Agenda – Executive Policy Committee – April 18, 2023

Report – Standing Policy Committee on Property and Development – April 6, 2023

Item No. 10 Subdivision and Rezoning – 1396/1400 Henderson Highway (North Kildonan Ward) File DASZ 56/2022 [c/r DCU 243689/2022D and DAV 243654/2022D]

SCHEDULE 'A'-PLANNING DISCUSSION

Figure 5: Sight line analysis and proposed building notch

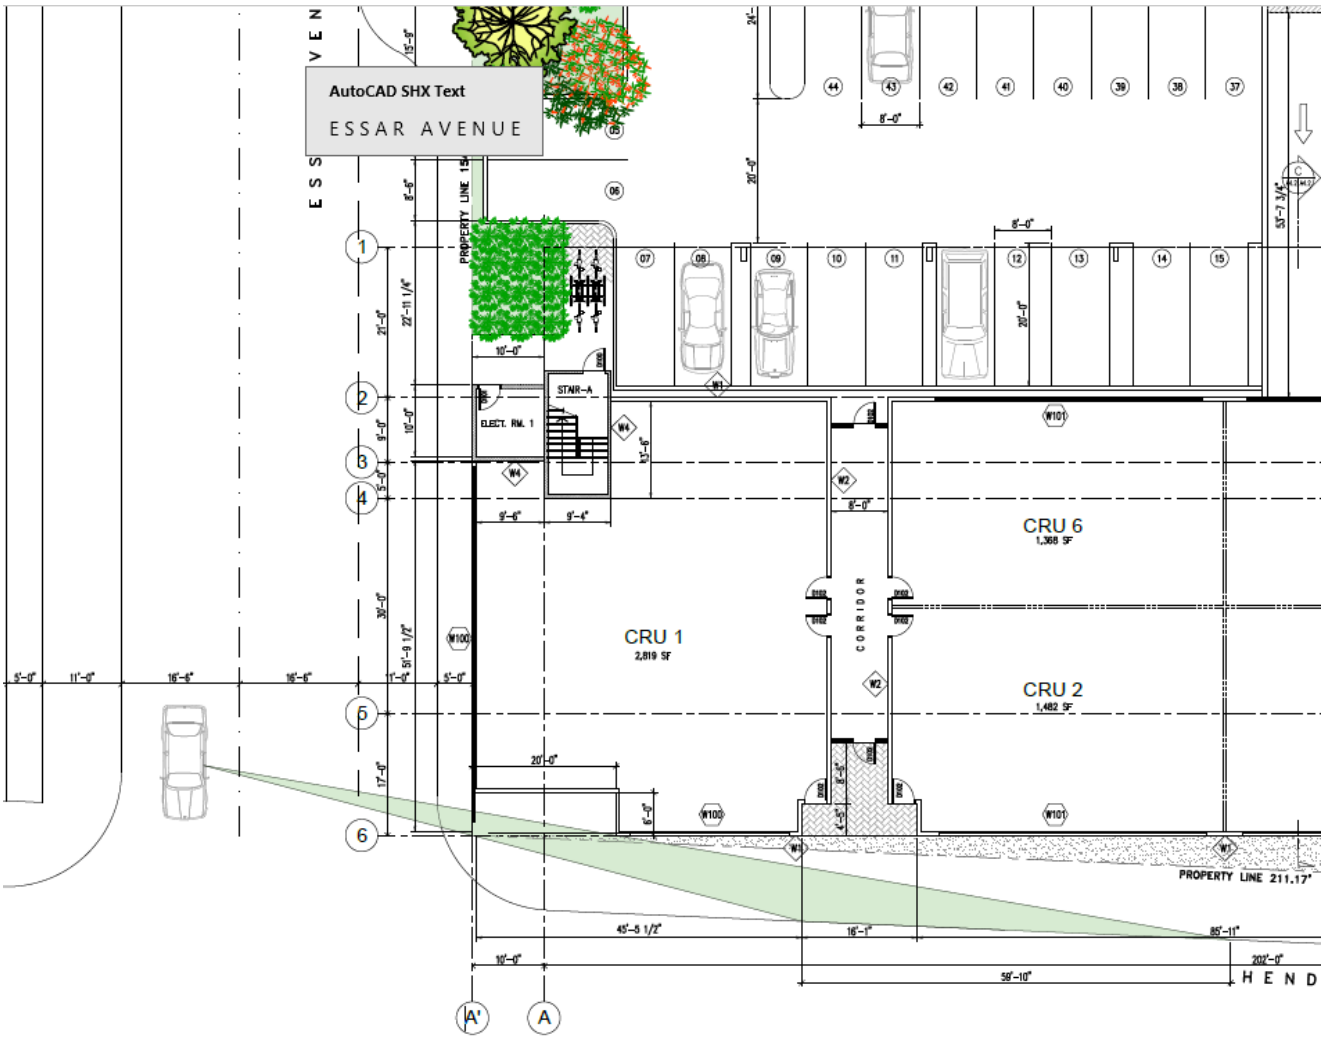
- This was communicated to the applicant who proposed a revised design that would create a 6 x 20 foot notch in the south east corner of the building to address sight line concerns (Figure 5)

- Public Works has indicated this design approach satisfied their concerns and is supportable.
- Unfortunately, this concern was identified late in the review process and there was not adequate time to update submitted drawings.

- The Urban Planning Division will ensure this building notch is incorporated into final designs at the Plan Approval phase.
